Technical Response Memo

Response to National Marine Fisheries Service (NMFS) Request for Information

DRAFT (4/24/15)

This technical memo addresses the comments received by the USACE from the National Marine Fisheries Service (NMFS). The NMFS comments included inquiries related to dredging impacts, potential effects on threatened and endangered species (specifically Atlantic sturgeon, shortnose sturgeon, and sea turtles), shoreline development, and wetland mitigation. Those issues are addressed in this technical memo and attachments. Based on the data and information provided, including a more detailed analysis of the potential impacts, PSEG believes that the potential new plant at the PSEG Site will not have a substantial and unacceptable impact on the aquatic resources of national importance in the Delaware Estuary / River and will not result in more than minor detrimental effects to endangered species.

Figure 1 – Sound propagation for in-water and nearshore construction activities for PSEG's New Units.

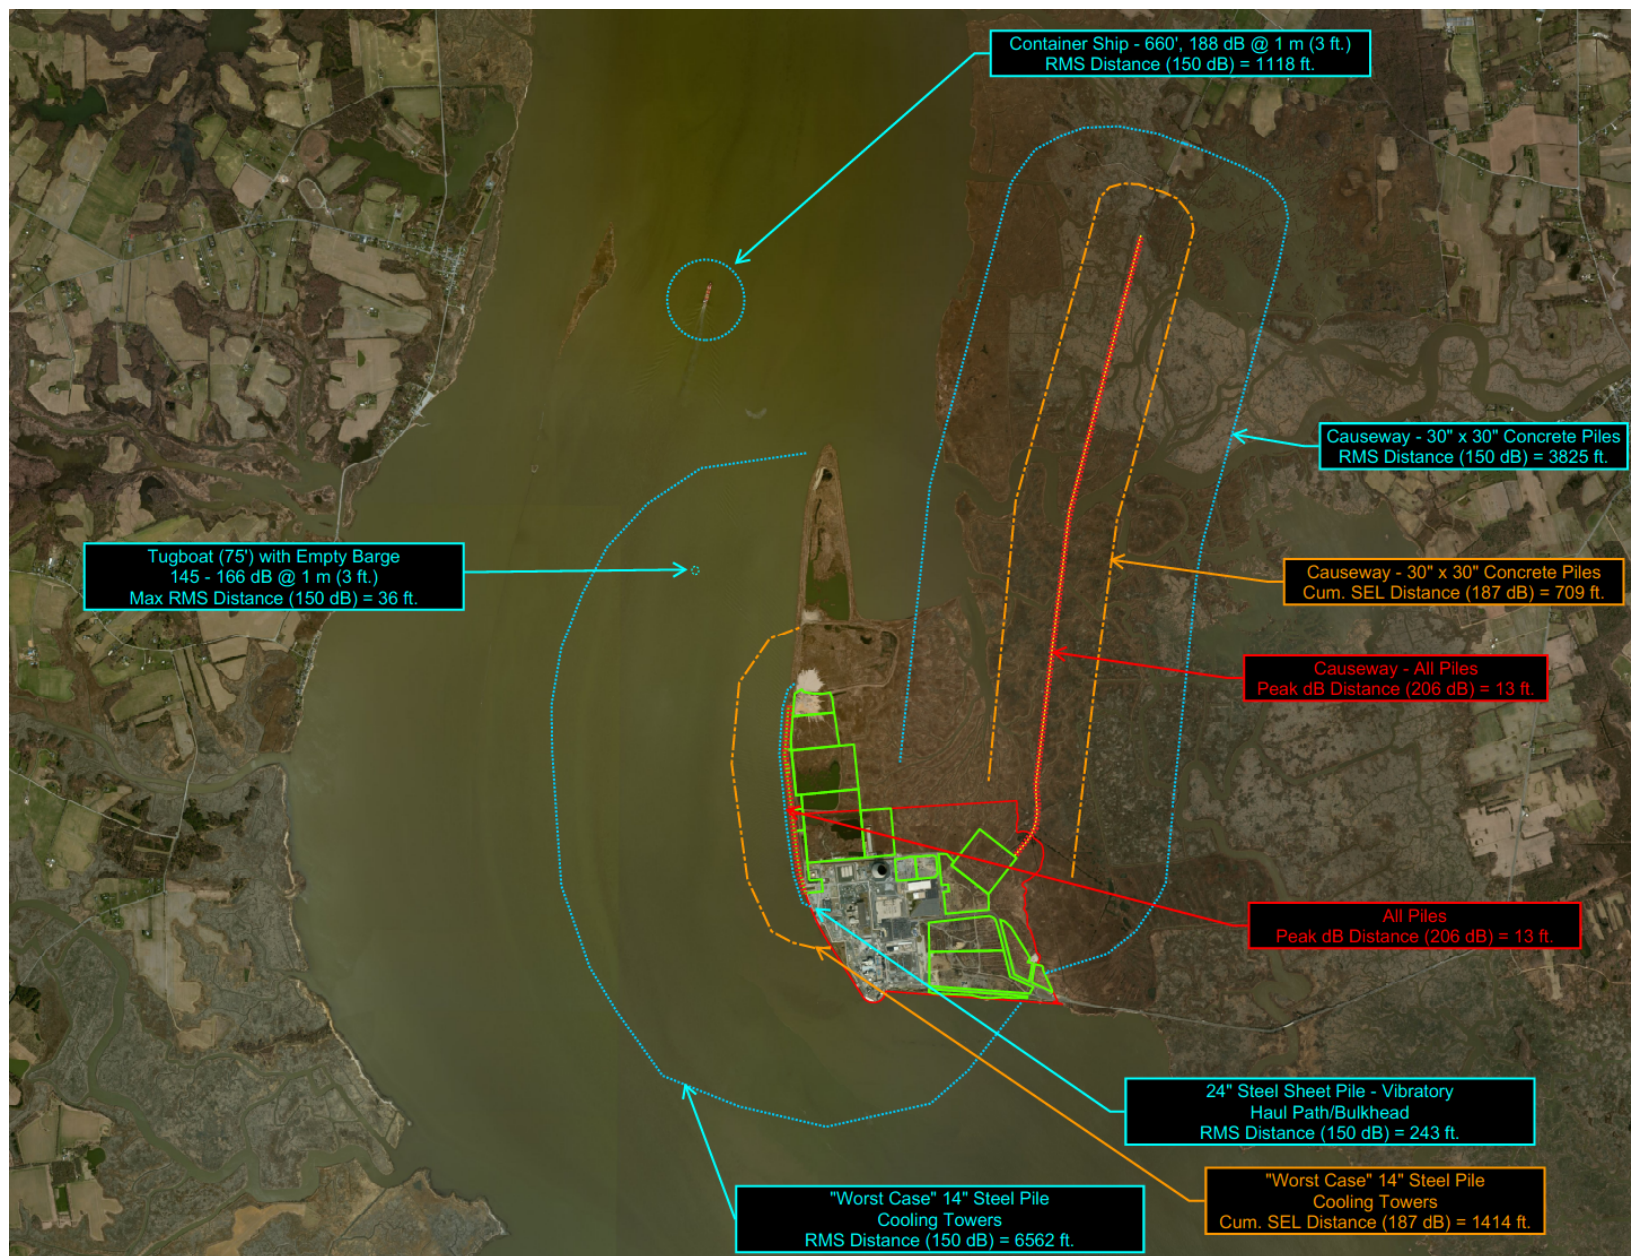
- **Types**
 - **steel**
 - **concrete**
 - **wood**
- **Number**
 - **sheet piles**
 - **pipe piles**
- **Size**
 - **length of sheet piles**
 - **diameter of pipe piles**
- **Installation**
 - **time of year**
 - **days per week**
 - **hours per day**
 - **drive time per pile**
 - **single or multiple piles driven at one time**
 - **types of substrate**
 - **water depths where pile driving would occur (bathymetry)**
 - **vibratory hammer or impact hammer**
 - **vibrate**
 - **impact — implementation of noise attenuation systems**
 - **ramp up or soft start method warning strikes**

PSEG used acoustical data from representative pile-driving studies, along with expected blow counts, to develop estimates of underwater-noise isopleths for the Peak Sound Pressure Level (SPL_{peak}), Cumulative Sound Exposure Level (SEL_{cum}), and Behavioral Root Mean Square Sound Pressure Level (SPL_{rms}). These were populated into each unique pile installation scenario into the NMFS's Pile Driving Calculations spreadsheet model (provided to PSEG by the USACE). The NMFS model calculates the distance within which the NMFS-established underwater noise criteria are exceeded.

Based on the NMFS model, the 206 dB SPL_{peak} is only exceeded immediately adjacent to pile driving activity. For all expected pile driving activity (in-water vibratory driven steel sheet piles, land-side impact driven steel pipe piles, and marsh plain driven concrete causeway piles), the maximum extent of the SPL 206 dB SPL_{peak} is within only 3.9 meters (13 feet) of the source.

For the 187 dB SEL_{cum} , the distance from the source for the proposed causeway within which the criterion is exceeded is 216 meters (709 feet); however, this distance includes

mostly vegetated marsh plain and shallow marsh creeks which are not habitat for Atlantic or shortnose sturgeon. For the “worst case” scenario (8,000 strikes per day for land-side 14” steel pipe cooling tower pilings), the maximum distance in the Delaware River within which the 187 dB SEL_{cum} is exceeded in the Delaware River is 431 meters (1,414 feet). This is 12.8% of the width of the Delaware River at Artificial Island (Figure 1). The isopleths presented in Figure 1 are conservative in that they assume sound is radiated from the entire project area rather than from a more localized area of construction (where much smaller, circular isopleth bands would be expected).

The SEL_{cum} criterion would not be expected to affect Atlantic or shortnose sturgeon in the Delaware River near the new unit construction. The SEL_{cum} zone does not form an up-river/downriver migration or movement barrier because it only extends to a maximum of 12.8% of the River's width, and sturgeon have exhibited a documented behavioral avoidance response to pile driving sounds that makes it unlikely that they will be exposed to noise levels as great as 187 dB SEL_{cum}.

For the 150 dB SPL_{rms} criterion (considered by NMFS to be the threshold at which fish may begin to avoid underwater noise), the zone within which this criterion is exceeded for the causeway piles extends up to 1,165 meters (3,825 feet) from the source. For the causeway, this zone comprises mostly vegetated marsh plain and shallow marsh creeks, as well as a shallow (<2' at MLW) Delaware River embayment east of Artificial Island.¹ For vibratory shoreline steel sheet pile installation at Artificial Island, the zone of RMS exceedance extends out to 74 meters (243 feet) from the source into the Delaware River. For the "worst case" land-side cooling tower pilings, the RMS criterion is exceeded out to 2,000 meters (6,562 feet) from the source into the Delaware River. This represents 47% of the river width at this location (Figure 1). The "worst case" is conservative in that it assumes all pile driving would occur along the shoreline, but in practice, most pilings would be a substantial distance from the shoreline (to landward). While Atlantic and shortnose sturgeon exhibit active behavioral avoidance to pile driving sounds, the Behavioral RMS zone does not represent a blockage to upriver/downriver movement or migration in light of the large portion of the river that would fall below the effective quiet level of 150 dB.

Figure 2 – Water levels relative to MLW. The red line indicates the project's deepest draft vessels within 3' (1 meter) of the bottom.

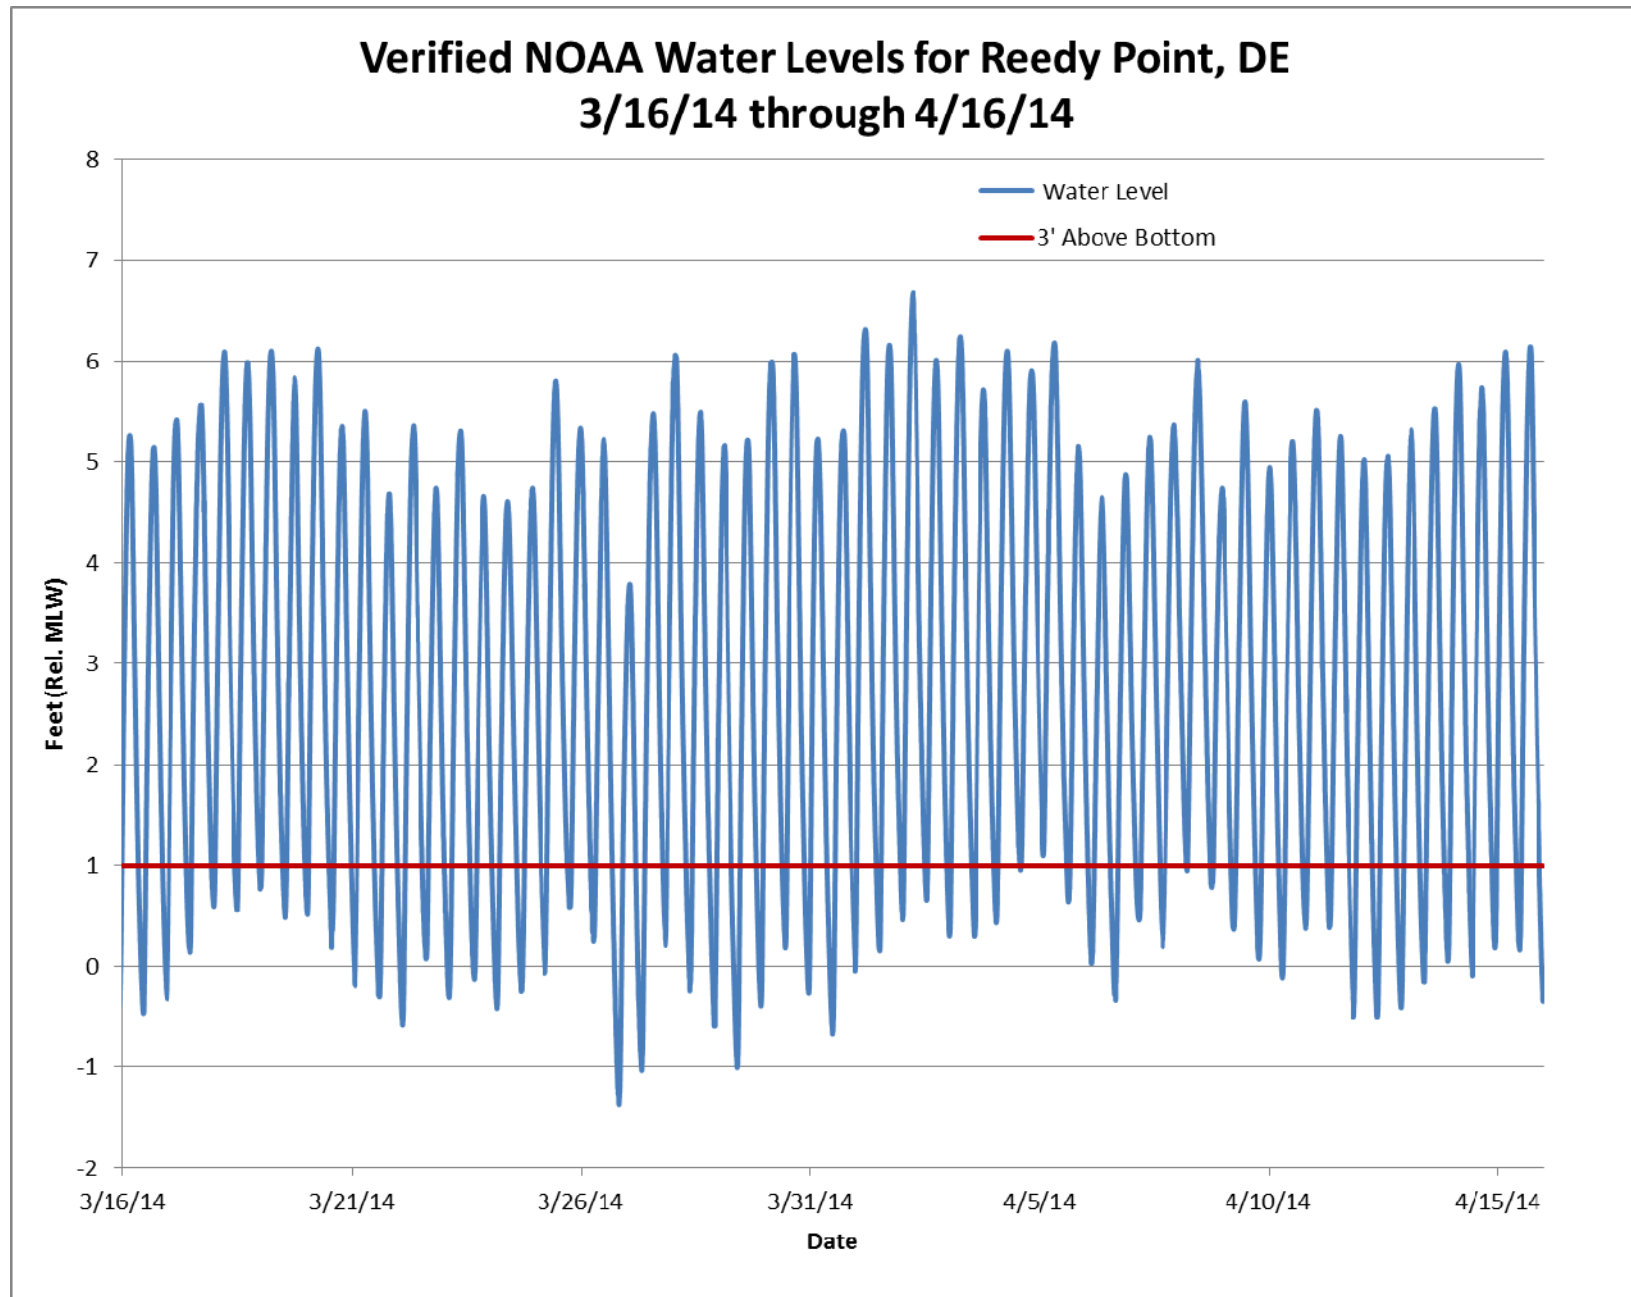
- **Types and dimensions used for installation activities (causeway, barge slip, intake and discharge installation)**
 - **Crane, construction, and material barges**
 - **hopper scows**
 - **workboats**
 - **tugboats**
- **Draft of vessels**
 - **navigational clearance (i.e., depth of water and draft of the vessel)**
- **Speed of vessels**
- **Duration of vessel traffic**
- **Number of vessel trips to and from Federal navigational channel**

Second, to assess the probability of project-related vessel traffic to approach within one-meter of the river bottom (the depth at which the bottom-oriented sturgeon spend the majority of time), the deepest draft vessels (those approaching two feet from the bottom at MLW) were evaluated based on local tide data to determine the frequency at which their hulls or propellers could be in the near-bottom zone. A query of NOAA tide data for the Reedy Point, Delaware gage (Station No. 8551910), referenced to local MLW elevation, is presented in Figure 2. Figure 2 also shows (relative to MLW) the depth of the deepest draft project vessels – that is, within two feet of the bottom plus one foot to account for the one-meter, or approximately three feet, sturgeon impact depth. In terms of percent of the time, and discounting operational factors that affect vessel movement into and out of the project area, the temporal distribution of the tidal elevations suggest that vessels could be within one meter of the bottom in the project area approximately 27% of the time.

When applied to the deepest draft vessels (from Table 3), of the projected 195 deep draft annual trips in the project area, only 53 could occur close enough to the bottom to physically contact sturgeon. In practice, this estimate is very conservative since the deepest draft vessels typically are used for the delivery of the largest, heaviest (and extremely high value / long lead time) power plant components (e.g., reactor vessels, steam generators, reactor heads, steam turbines, etc.). Delivery of these critical components necessitates extreme conservatism on the part of vessel operators and will be timed to coincide with high tides to avoid vessel grounding. They would also occur during calm weather to facilitate maneuvering, and vessels typically will be travelling slowly to maintain precise control. As such, the likelihood of any sturgeon strikes from the deeper draft vessels is low.
